SUBJECT: FLOOD CONTROL DISTRICT: Approve Change Order, Contract Increase, and Notice of Completion for Desert Hot Springs MDP Line E-5, Stage 1, Project No. 6-0-00035-01, District 4. [\$269,240 – District funds 100%] (4/5 Vote Required)

Project Name: Desert Hot Springs MDP Line E-5, Stage 1

Project No.: 6-0-00035-01

CONTRACT CHANGE ORDER NO. 2

Photo 1 - Gas Line Discovered in Storm Drain Alignment

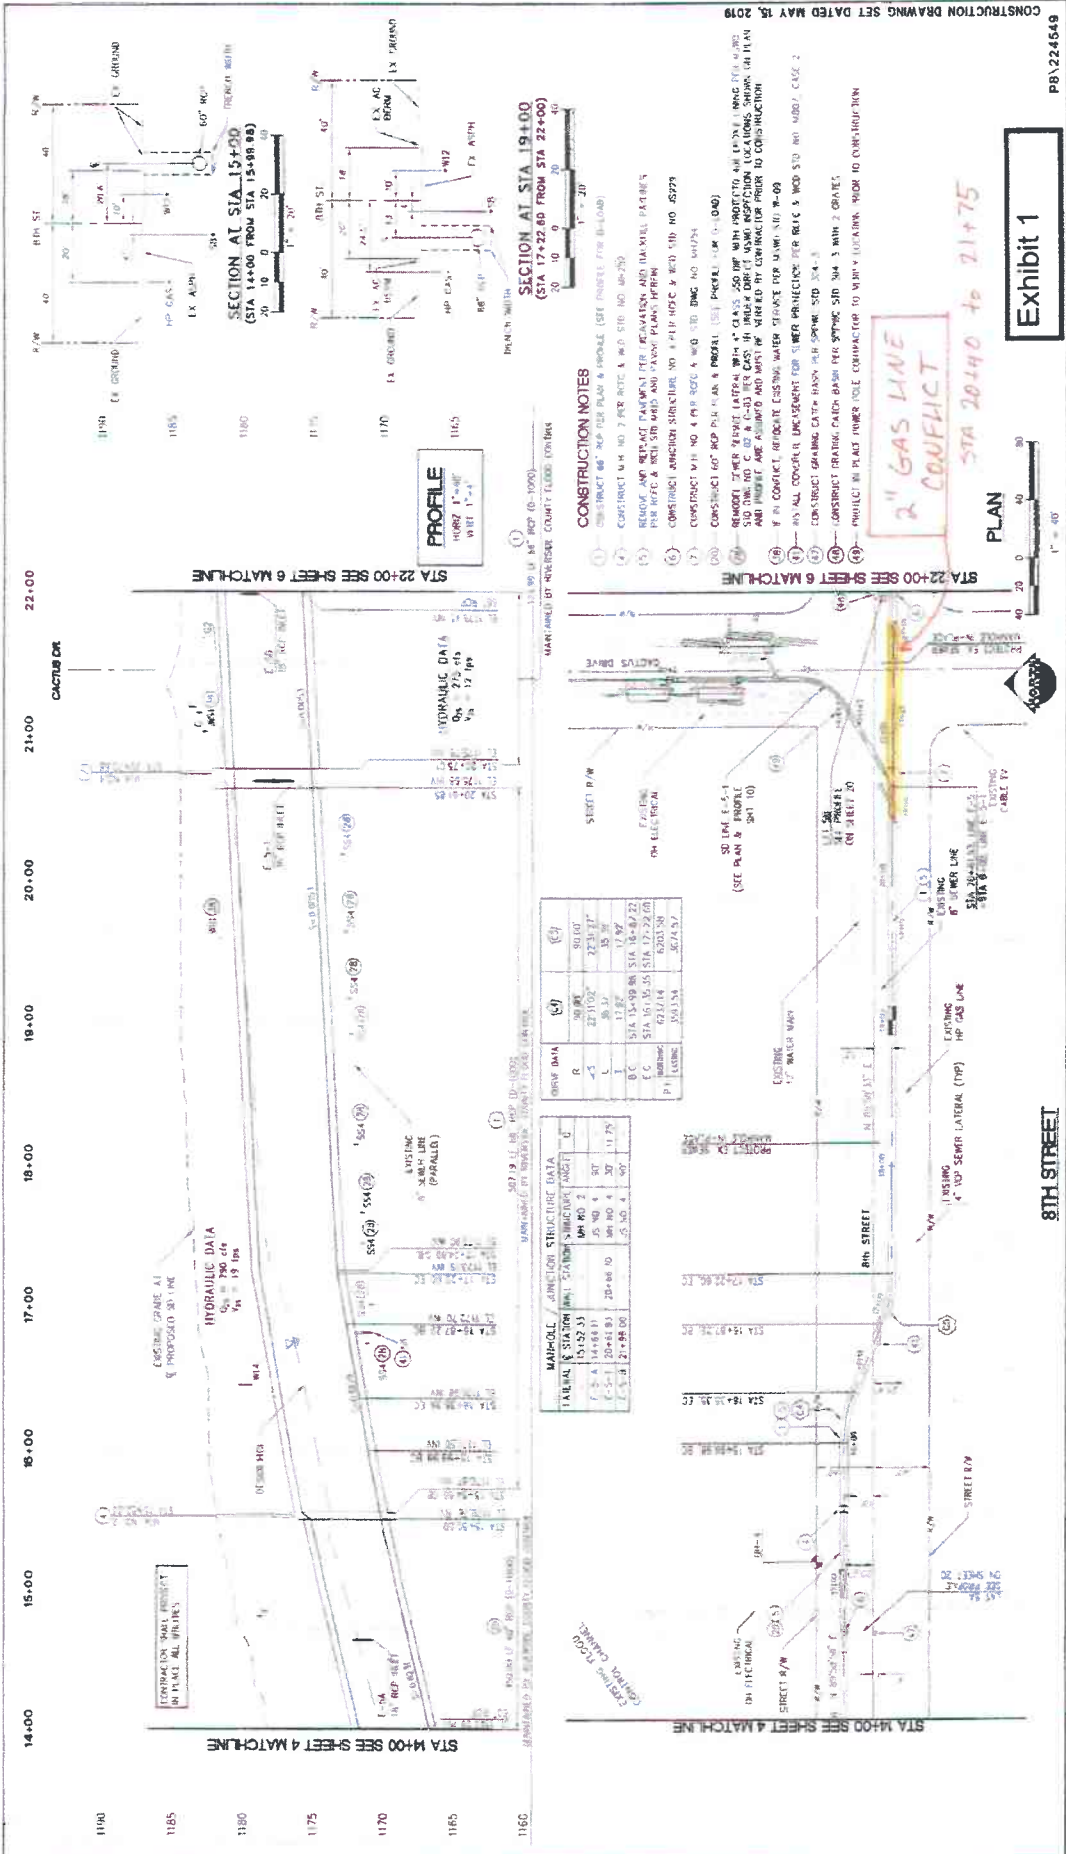
Change Order No. 2: Is necessary due to an unforeseen and unmarked 2" gas line located within the same alignment as the proposed 66-inch reinforced concrete pipe storm drain. The District coordinated with the Gas Company who relocated the gas line at their cost.

During the construction of the Desert Hot Springs MDP Line E-5, Stage 1 project (Project), the District's Contractor, O'Duffy Bros., Inc., encountered a 2" gas main that was marked incorrectly on the plans. The Gas Company and the District were unaware there was an active line at that location. The gas main was struck, then repaired by The Gas Company, the owner of the public utility. See attached Photos 1 and 2. Potholing was performed by O'Duffy Bros., Inc., to help The Gas Company find their gas line in order to determine the scope of the relocation. The unforeseen and unmarked 2" gas line was located within the same alignment as the proposed 66" reinforced concrete pipe storm drain. The conflict existed between Stations 20+40 to 21+75 and Stations 22+90 to 26+75 which is an approximate length of 520 linear feet. See Exhibit 1 which includes Sheets 5 and 6 of Drawing No. 6-0410. An abandoned 2" steel line was incorrectly marked as an active line and this information was reviewed and confirmed by The Gas Company. The District coordinated with The Gas Company and the gas line relocation planning and construction occurred between the dates of January 7, 2020 and April 1, 2020. The new gas alignment was placed in the location of the abandoned line. See Exhibit 2, Gas Relocation. However, during that time, O'Duffy Bros., Inc. could not construct the mainline.

Photo 2 - Gas Line Repaired in Storm Drain Alignment

Exhibit 1

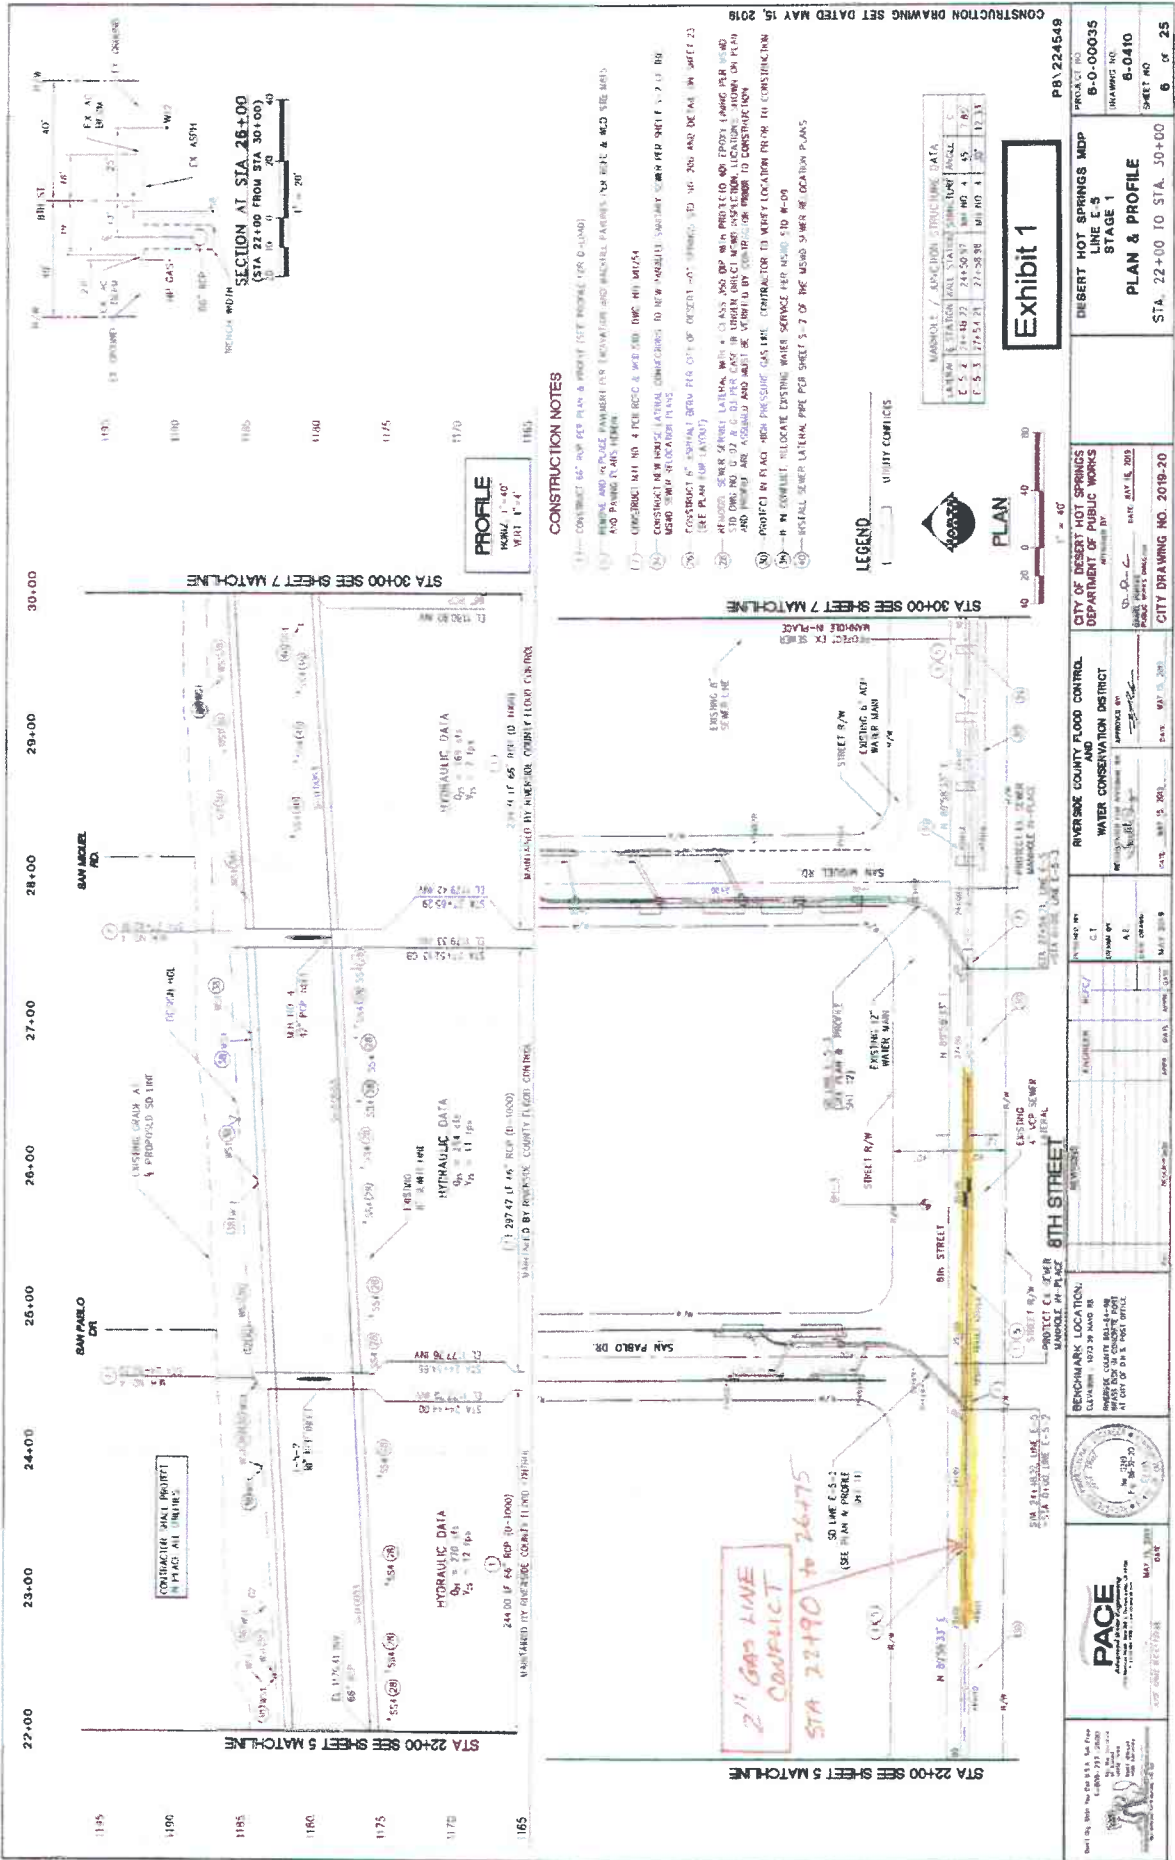
**2" GAS LINE
CONFLICT**

STA 20140 to 21+75
